date: March 4, 2023
to: Jennifer Hofmeister-Drew, AICP, LCAM, Planner III,
Town of Palm Beach
from: Eric Czerniejewski, P.E., ENV SP
subject: Paramount Palm Beach Traffic Review

MEMORANDUM

The Corradino Group, Inc (Corradino) has been requested to provide a traffic review of the Traffic Impact Evaluation for the redevelopment of the Paramount Theatre located at 139 North County Road in the Town of Palm Beach, Florida. The following are our traffic review comments based on the 02/27/23 resubmittal.

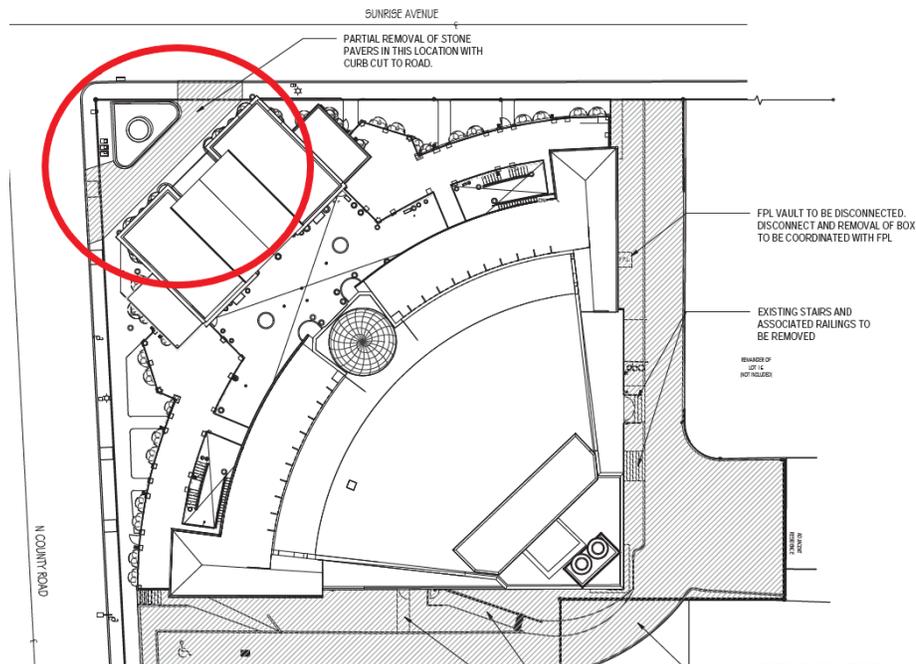
12. Please provide additional narrative that provides the total amount of queuing available from the valet stand to the adjacent road network for both scenarios. Figures 3 and 4 should be updated to denote the total amount of queuing available from the valet stand to the adjacent road network.

TCG 03/04/23 Response: This item is still pending.
